URGENT MEDICAL DEVICE UPGRADE NOTIFICATION

RE: STRYKER SONOPET CONSOLE

July 11, 2014

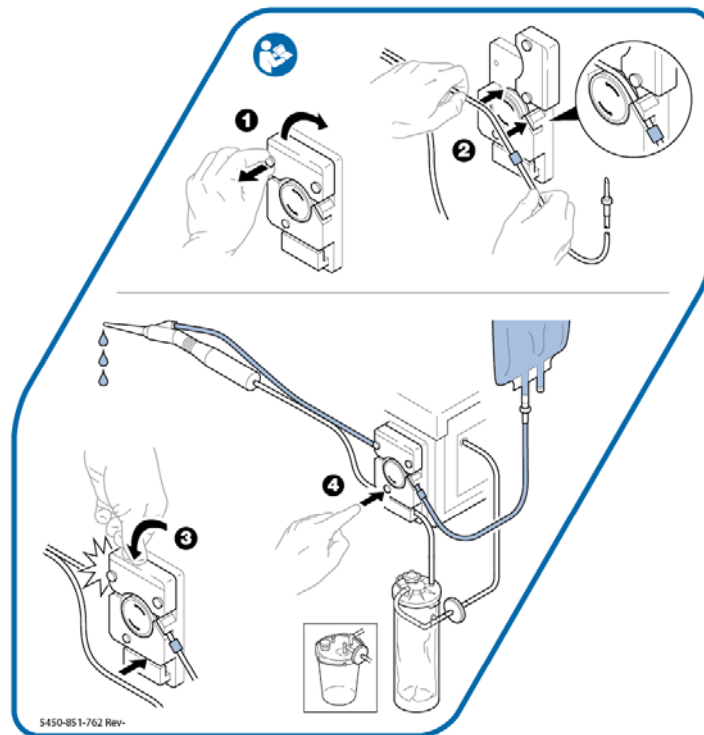
Stryker is sending you this URGENT MEDICAL DEVICE UPGRADE NOTIFICATION to update documentation to clarify how to set up a Sonopet system. This label upgrade includes an update to the Instructions for Use (IFU) and an on-device instructional label for proper irrigation set up.

All existing Sonopet consoles will have an instructional irrigation setup label applied to the side of the console.

- DO NOT use a rigid non-collapsible irrigation container. Failure to comply may cause the flow of irrigation to be drastically reduced and result in overheating of the handpiece tip and/or tip cover. Only use a collapsible irrigation container.
- The irrigation tube must be properly routed through the irrigation pump with the pump cover fully closed and latched. Improper setup of the irrigation tubing may result in an inconsistent or lack of irrigation.
- Provide adequate irrigation to the tip to avoid excessive heat that could result in tissue damage due to unintended contact.
